CITY OF CAMBRIDGE
BUILDING DIVISION

6.10m TOWNS
WILLOW
MODELS
TH-43 TO TH-48

BASEMENT PLANS ELEV-2

BARLASSINA CONSTRUCTION
CAMBRIDGE, ONTARIO

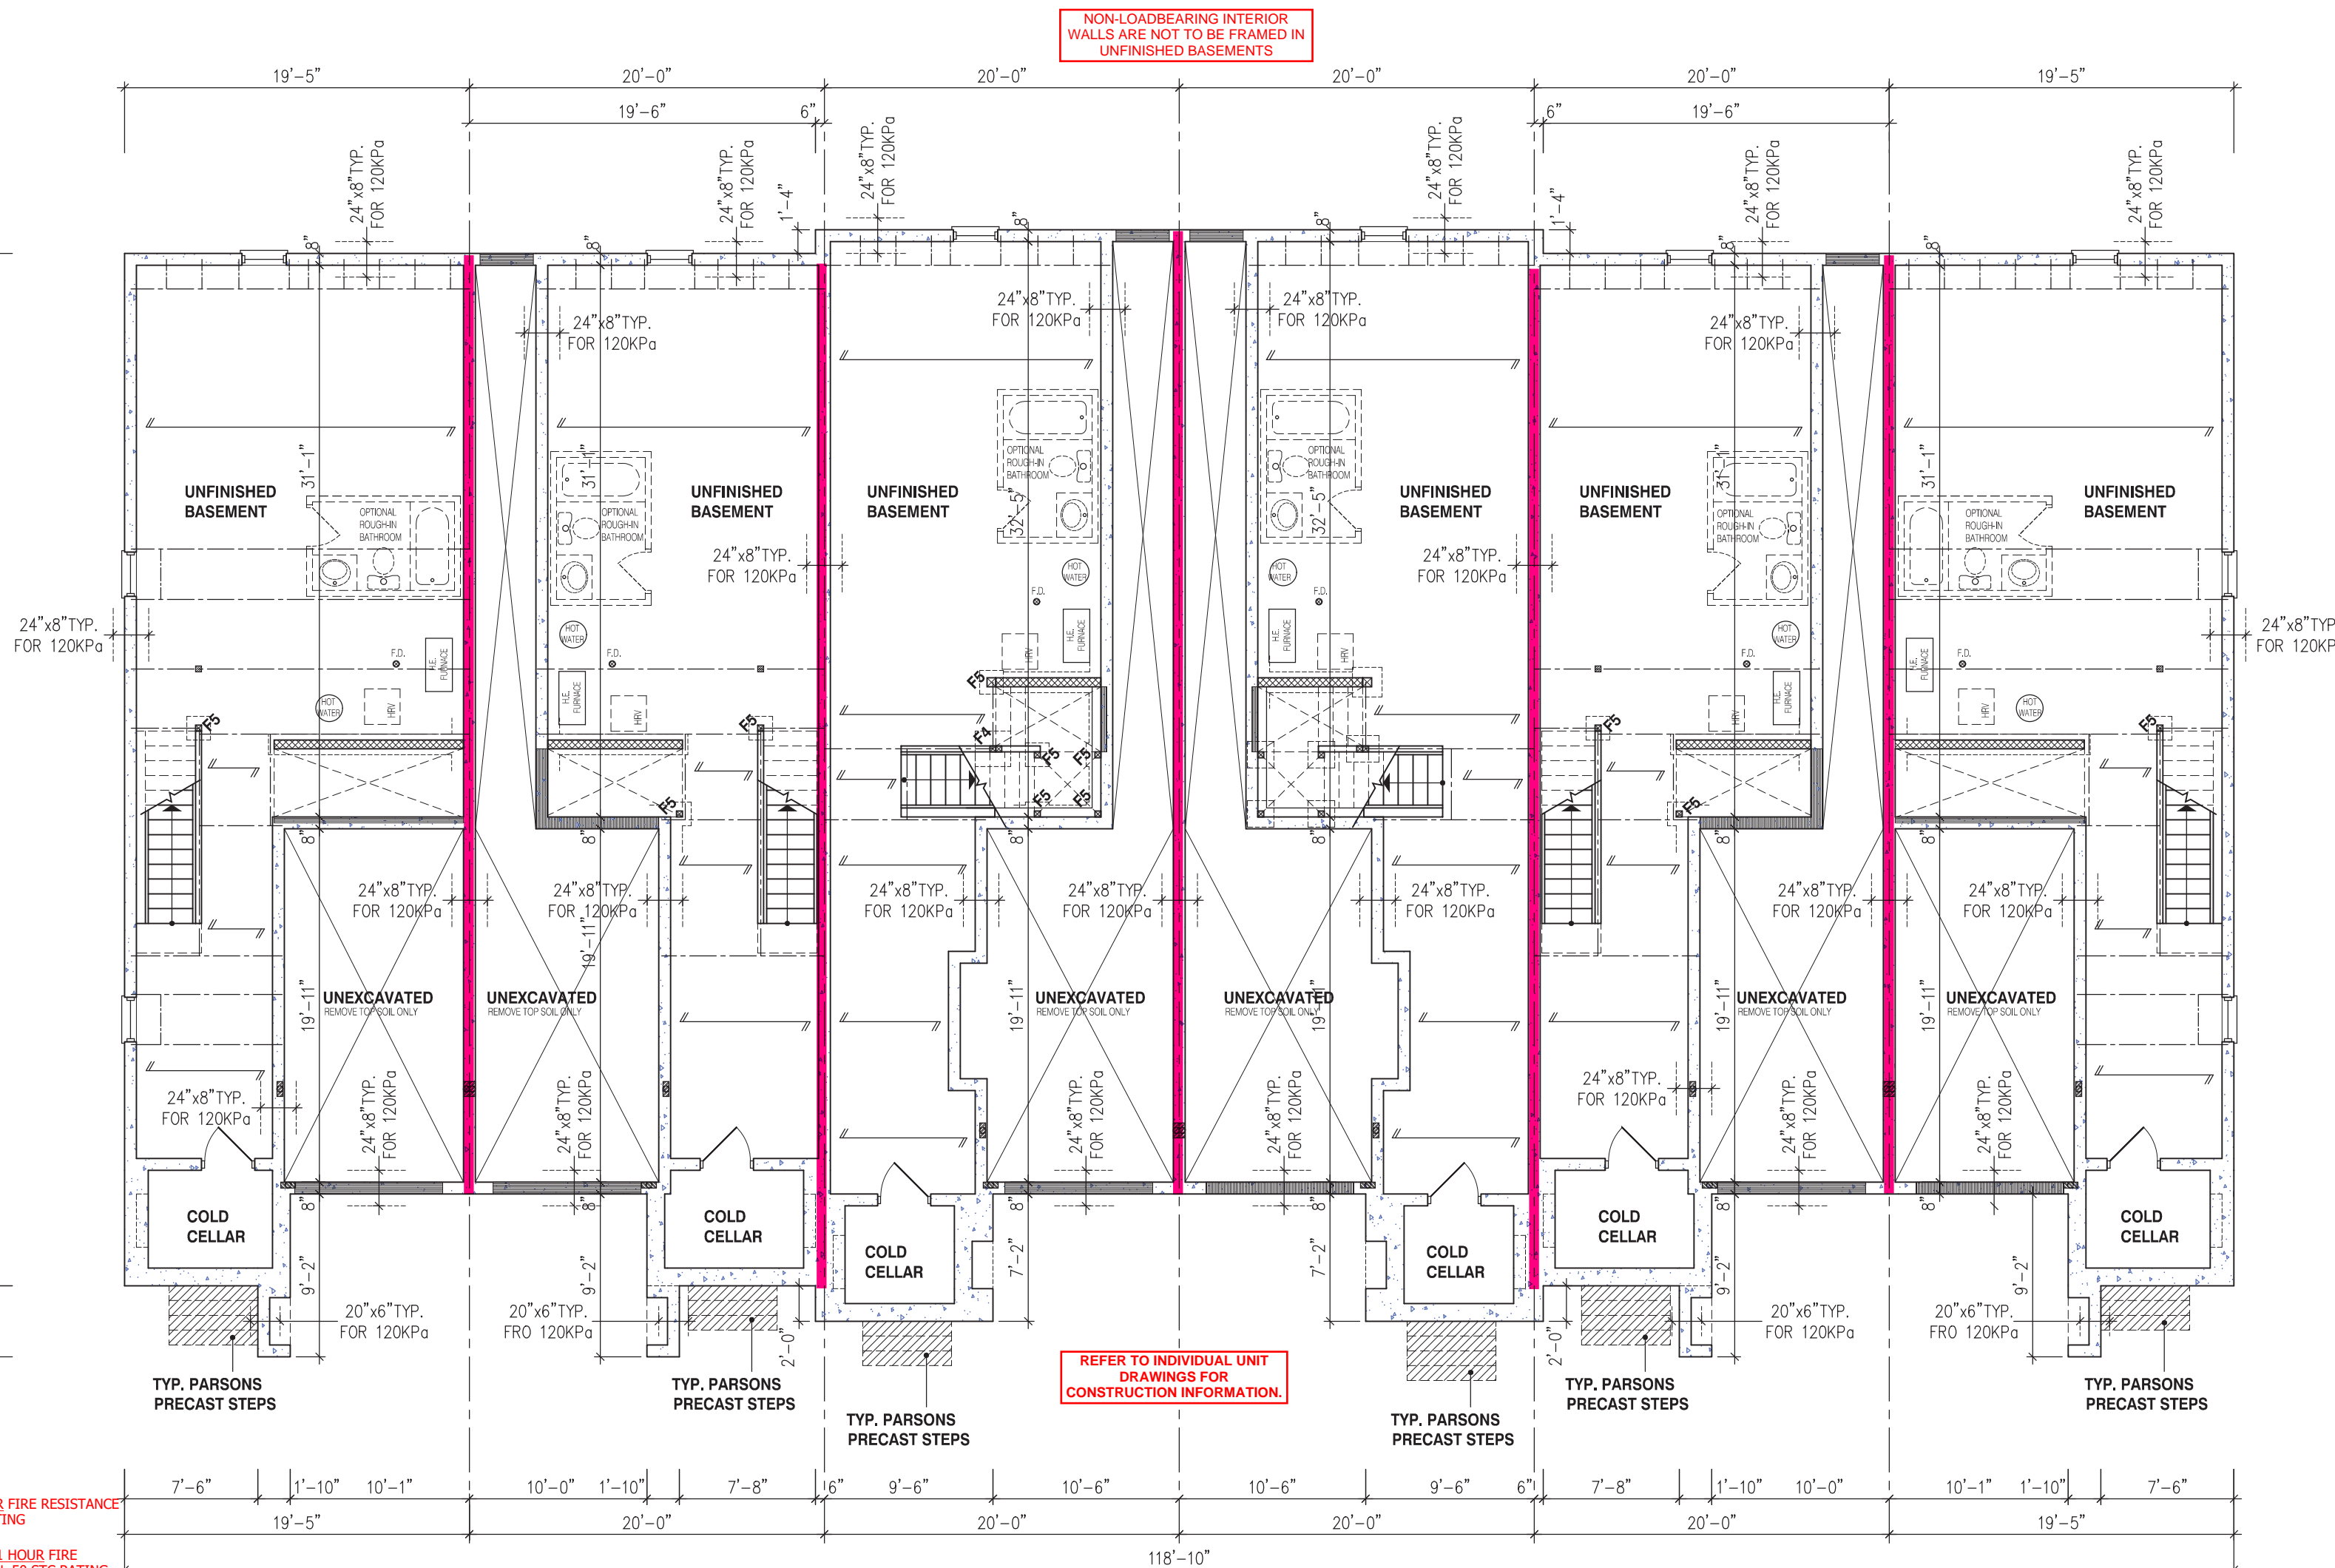
- FLOOR JOIST LAYOUTS & INSTALLATION MANUAL SHALL BE AVAILABLE, AT FRAMING INSPECTION.
- BLOCKING REQUIRED UNDER ALL POINT LOADS MUST BE TO SUITABLE BEARING.
- SEE ATTACHED REQUIREMENTS FOR FIELD GLUED FLOORS WHERE REQUIRED.

NO MODIFICATIONS TO FLOOR FRAMING DESIGN SHALL BE MADE UNLESS A REVISION HAS BEEN SUBMITTED FOR REVIEW AND APPROVED BY BUILDING DEPT. PRIOR TO FRAMING INSPECTION

REINFORCING REQUIRED IN FOUNDATION WALL OR PORCH SLAB SHALL BE REVIEWED PRIOR TO POURING CONCRETE (see inspector)

PROVIDE P.ENG APPROVED TRUSS & FLOOR DRAWINGS AND SPECIFICATIONS TO BUILDING INSPECTOR AT FRAMING INSPECTION

SINGLES - WEEPING TILE REQ'D AROUND EACH UNIT CONNECTED TO SEPARATE SUMPS/DRYWELLS
TOWNHOUSES - WEEPING TILE MAY CIRCLE ENTIRE BUILDING AND BE CONNECTED TO 1 SUMP/DRYWELL

A SEPARATE PERMIT IS REQUIRED FOR THE FINISHING OF ALL ROUGH-IN PLUMBING FIXTURES

FIRST FLOOR PLAN ELEV-2

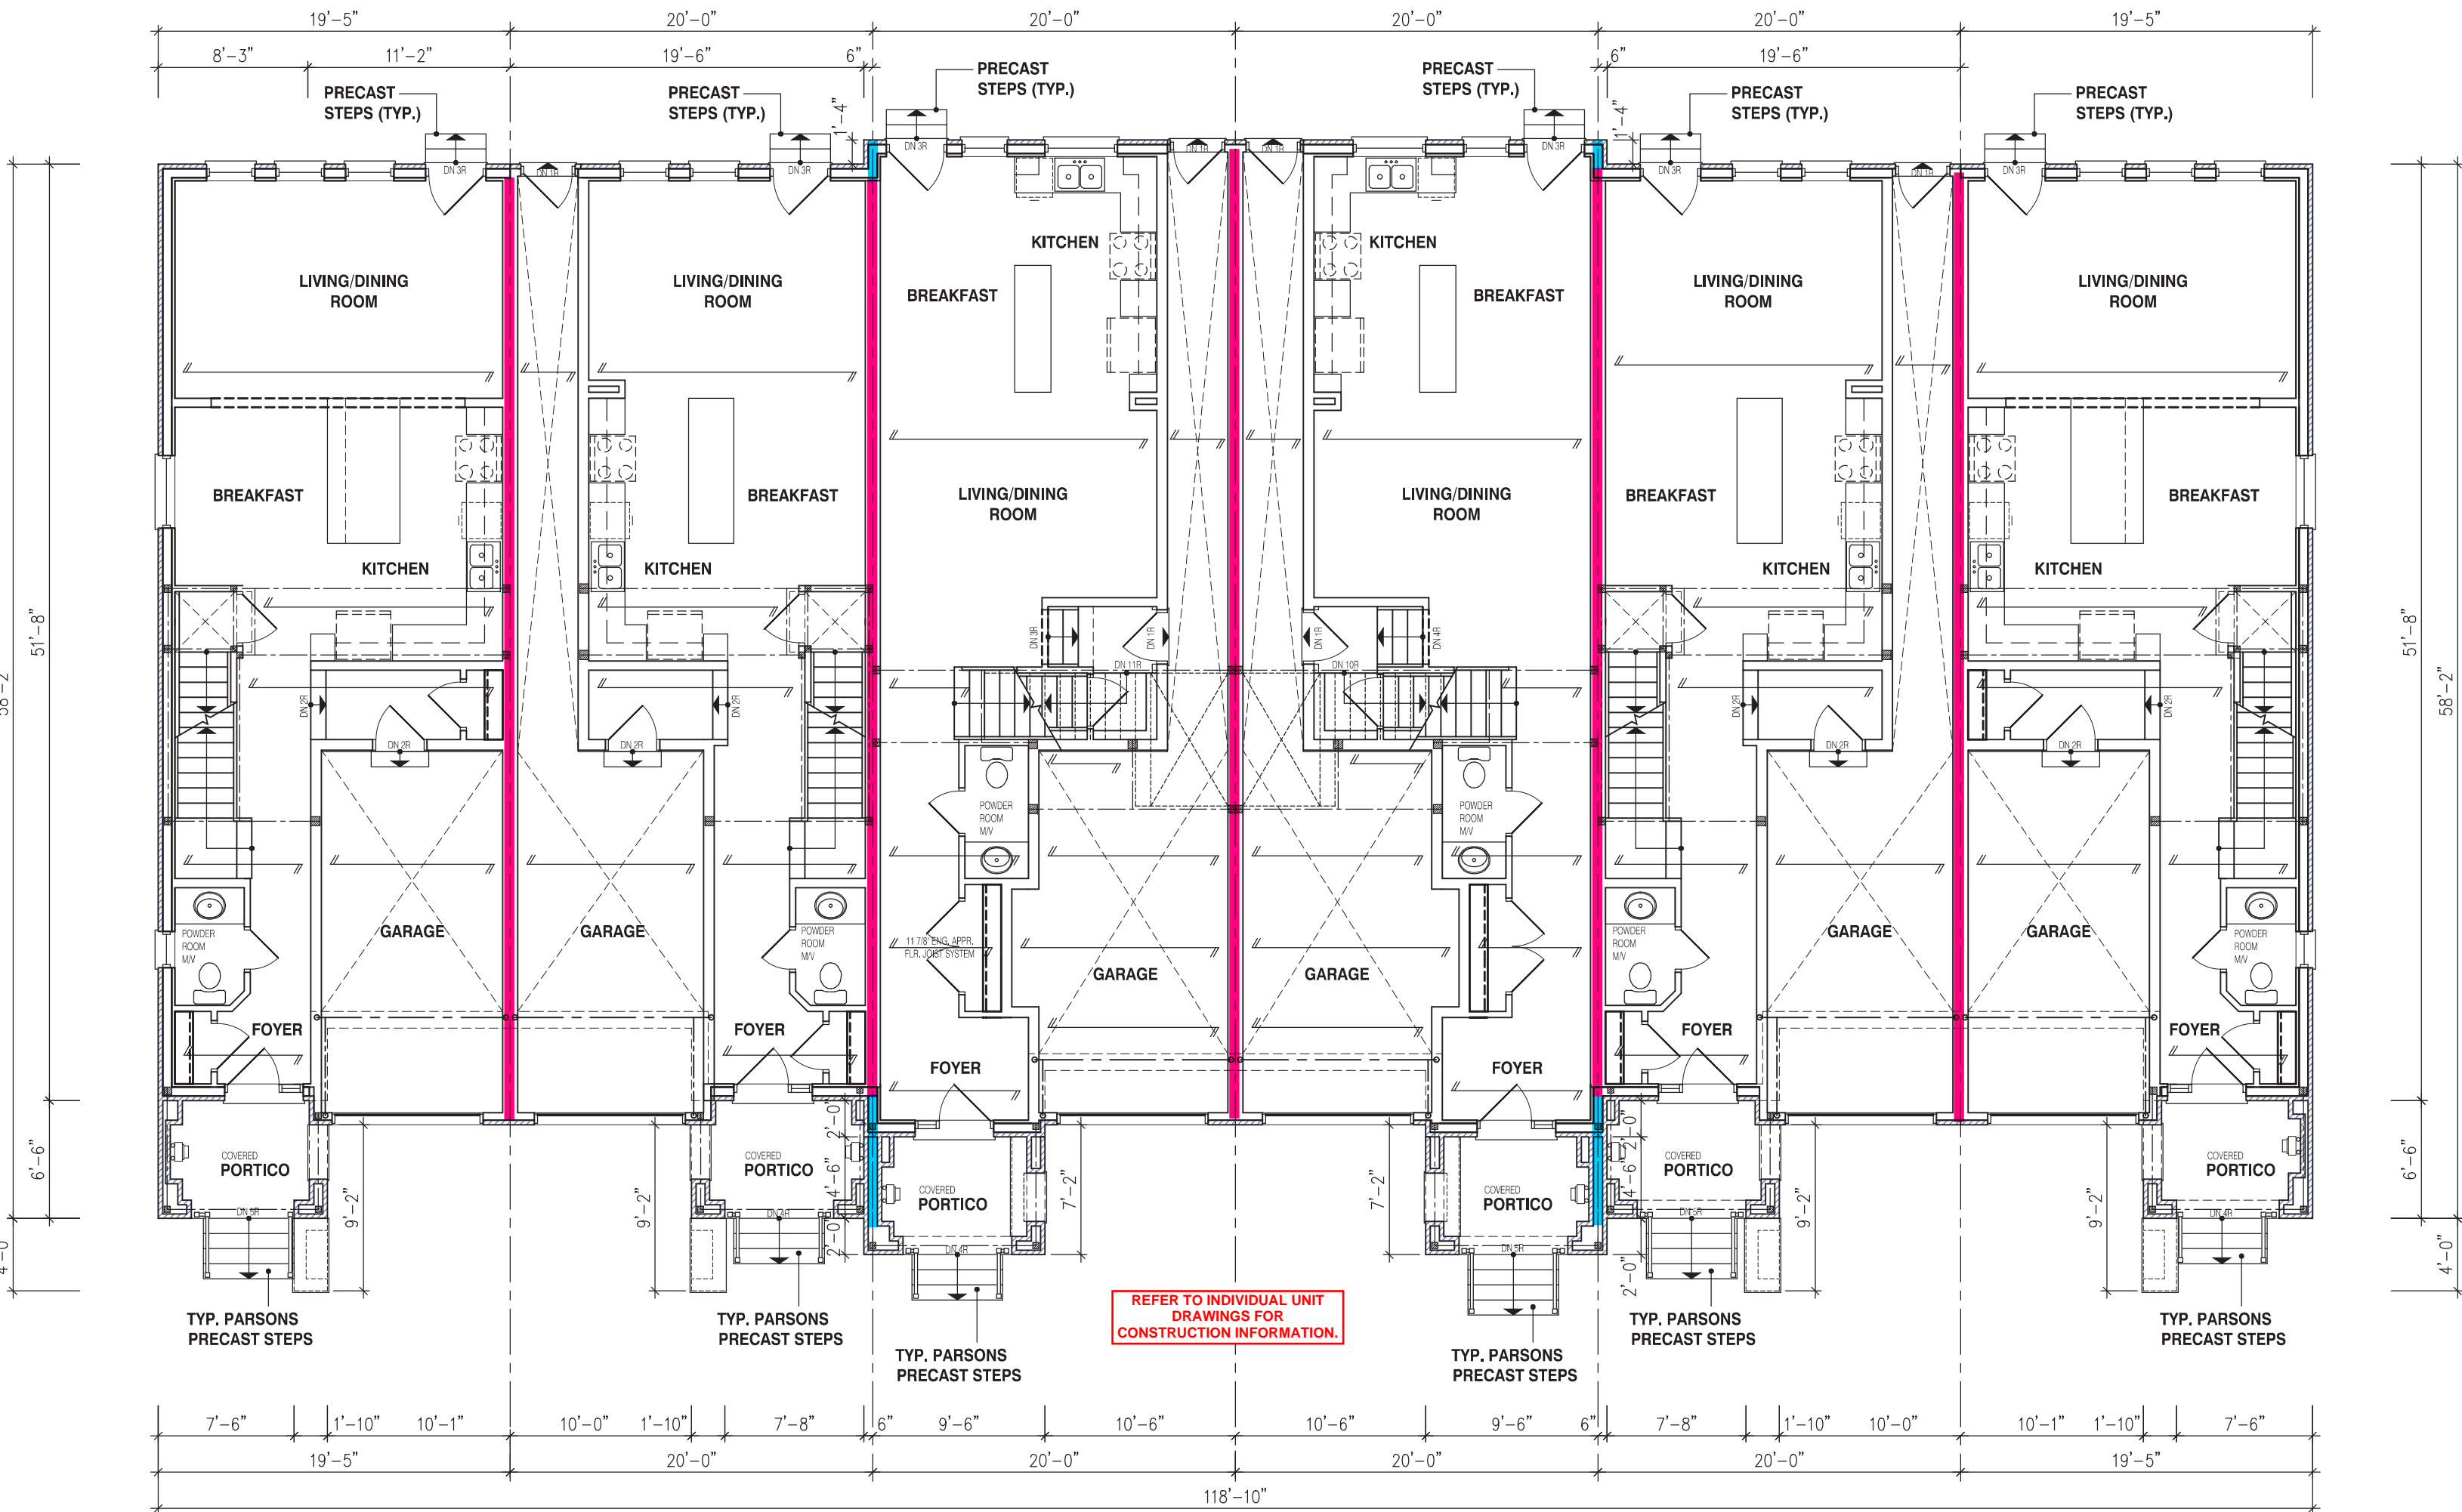
MAIN BATHROOM TO HAVE STUD BLOCKING FOR FUTURE INSTALLATION OF GRAB BARS ADJACENT TO SHOWER/TUB AND TOILET

TIGHTLY FIT ELECTRICAL BOXES WHERE BOXES ARE LOCATED ON BOTH SIDES OF A WALL PROVIDING A F.R.R., OFFSET BOXES AT LEAST ONE STUD SPACE TO MAINTAIN INTEGRITY OF FIRE SEPARATION

THE ONTARIO BUILDING CODE REQUIRES THAT A SMOKE ALARM BE INSTALLED ON EACH FLOOR LEVEL AND WITHIN EACH SLEEPING ROOM. ALL SMOKE ALARMS SHALL BE INTERCONNECTED. EACH DEVICE SHALL HAVE A VISUAL SIGNALING COMPONENT IN ADDITION TO THE TEMPORAL PATTERN IN CONFORMANCE WITH 18.5.3. OF "LIGHT, COLOUR AND PULSE CHARACTERISTICS" OF NFPA 72

A CARBON MONOXIDE DETECTOR SHALL BE LOCATED ADJACENT TO SLEEPING AREAS

FIRESTOPPING IN FIRE SEPARATION SHALL BE OF THE BATT INSULATION TYPE TO MAINTAIN REQUIRED STC RATING

UNPROTECTED COMBUSTIBLE PIPING NOT ALLOWED TO PENETRATE A FIRE SEPARATION OR A MEMBRANE FORMING PART OF AN ASSEMBLY REQUIRED TO PROVIDE A FIRE-RESISTANCE RATING

BLOCK 122
FRONT ELEVATION 2

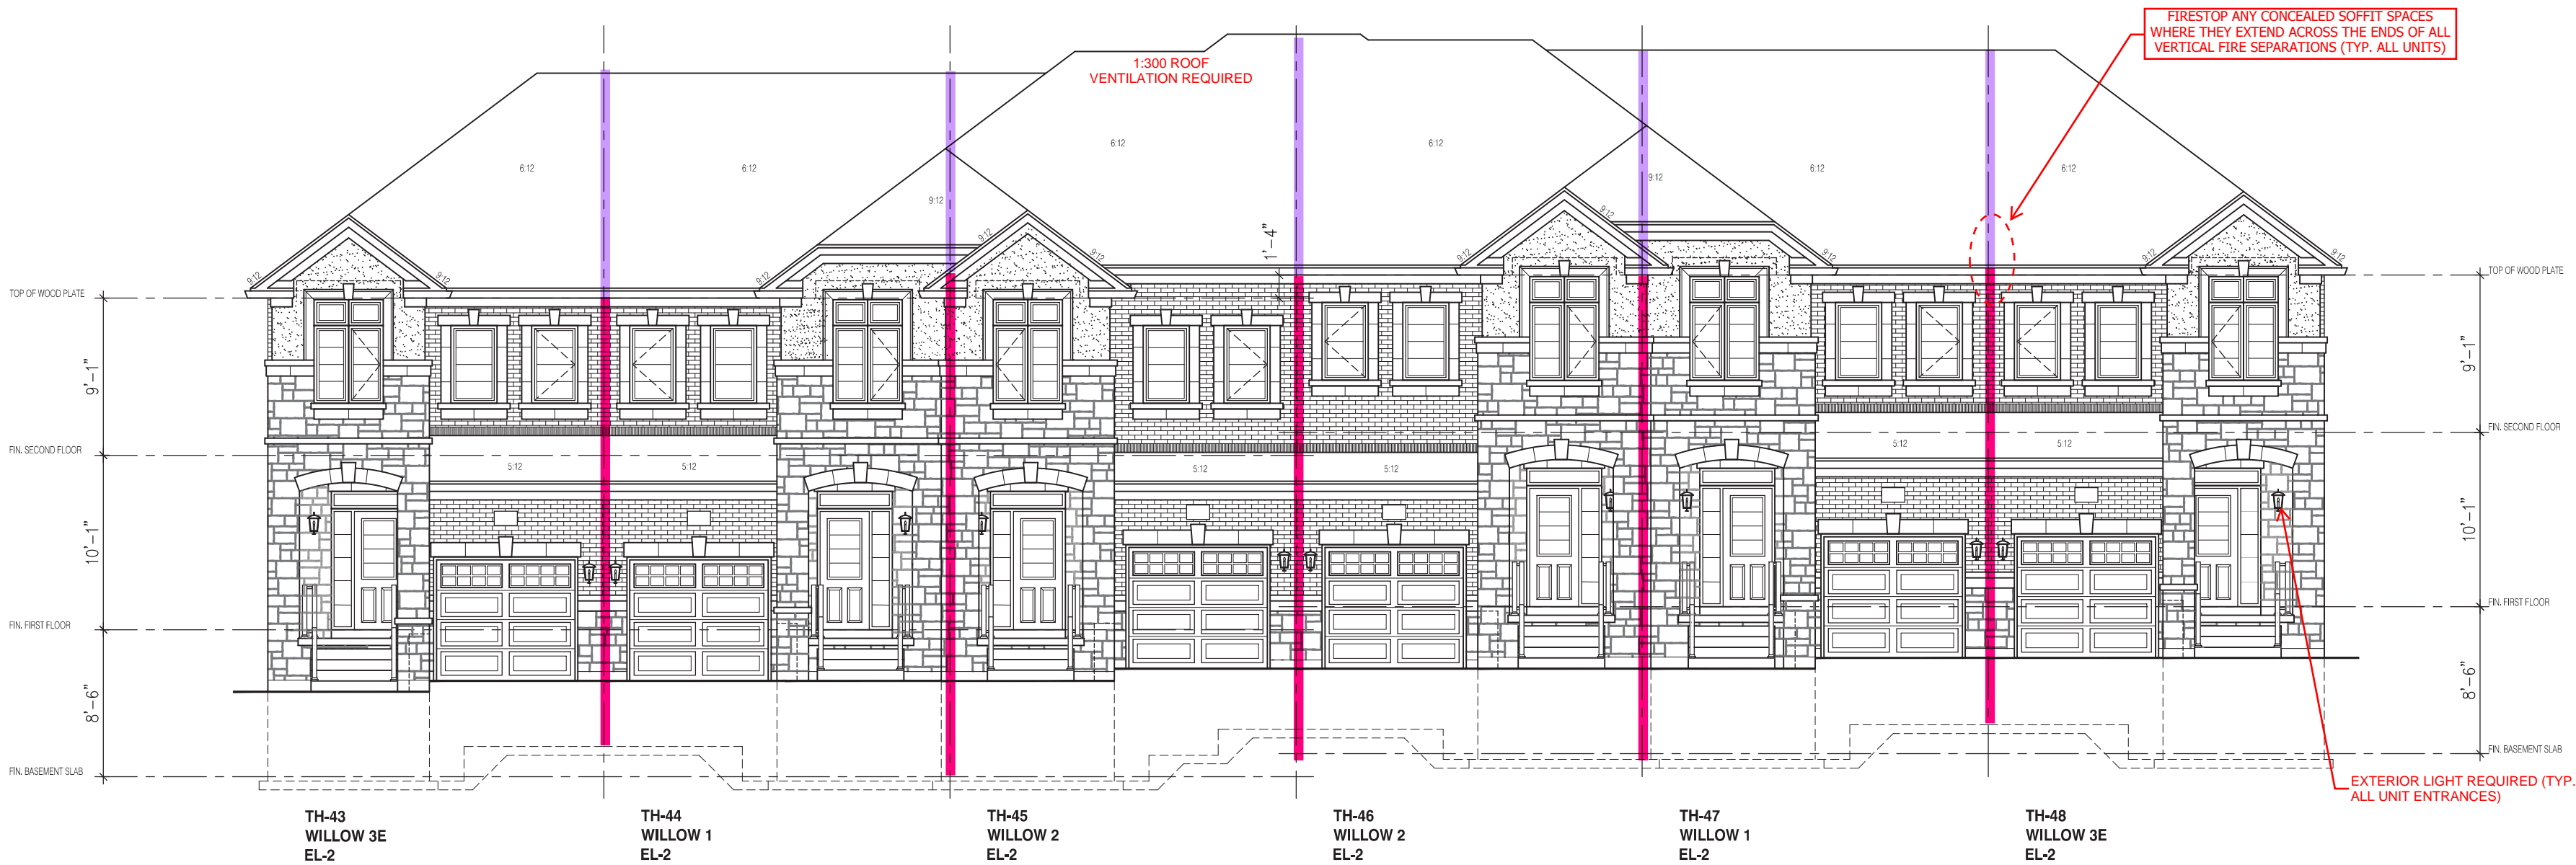
ENSURE P.ENG STAMPED RAILING DOCUMENTATION AND ATTACHMENT DETAILS ARE AVAILABLE FOR REVIEW BY THE INSPECTOR

EXTERIOR CONCRETE STAIRS w/ MORE THAN 2 RISERS TO MEET THE REQUIREMENTS OF 9.8.9.2.(1)
